Environmental Planning Commission

*Agenda Number: 02
Project Number: 1009920
Case Number: 17EPC-40070
Hearing Date: February 8, 2018*

Staff Report

Agent	Rick Bennett
Applicant	Doug Adams
Request	Deviations to the East Gateway Sector Plan (Site Development Plan for Building Permit)
Legal Description	Lot 1-A block 48 Skyline Heights
Location	Eubank NE, Between Bell Ave and Trumbull Ave
Size	1.5 acres
Existing Zoning	SU-2 M-1
Proposed Zoning	Same

LANDSCAPE PLAN
SCALE: 1"=40'-0"

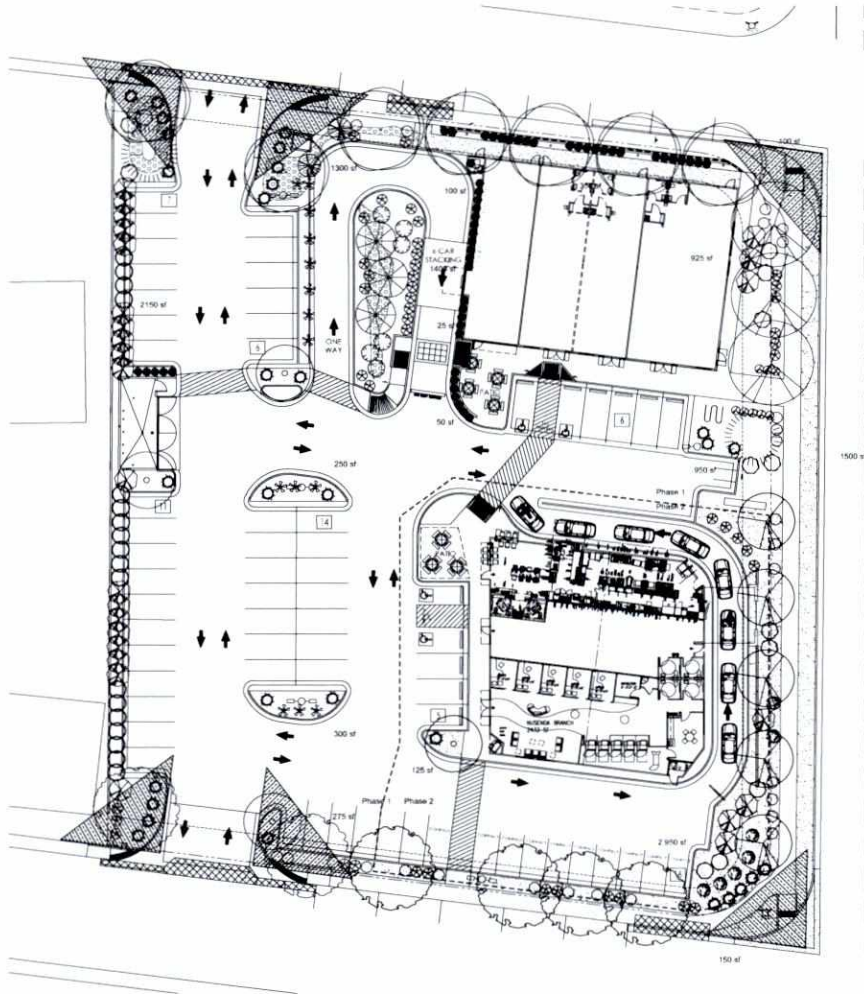
3. On Sheet L-1.0, Landscape Plan, the proposed tree selection, Arizona Ash, is not a compatible height at maturity with the existing overhead electric transmission line along the eastern boundary of the site. A shorter tree selection at mature height is necessary at this location. The PNM landscaping preference is for trees and shrubs to be planted outside the PNM easement; however, if within the easement, trees and shrubs should be located to minimize effects on electric facility maintenance and repair. New trees planted near PNM facilities should be no taller than 25 feet in height at maturity to avoid conflicts with existing electric infrastructure.

What is the heavy dashed line on Sheet L-1.0? It does not appear on the overall site plan.

What are the phases? Is this for the Landscape plan or the whole project?

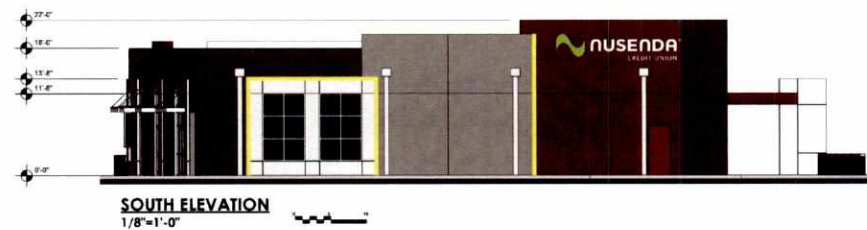
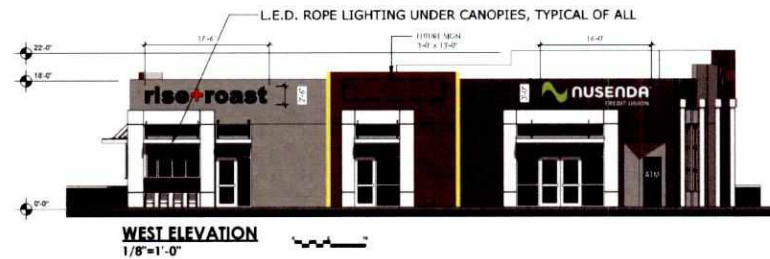
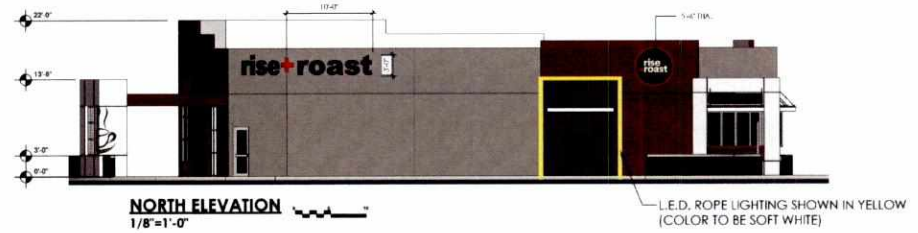
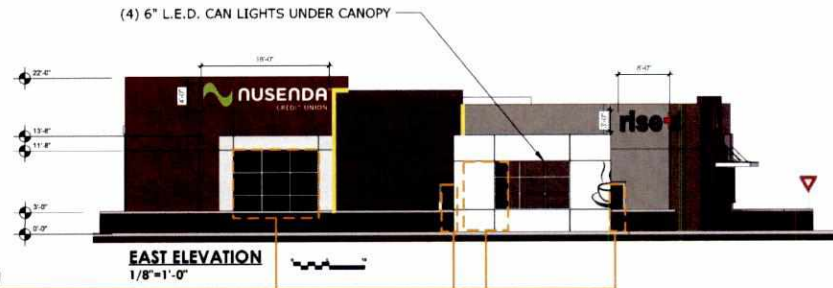
The EGSDP requires glazing on 40% of the façade area between the sidewalk and 9 feet above. The windows comply with the plan requirement.
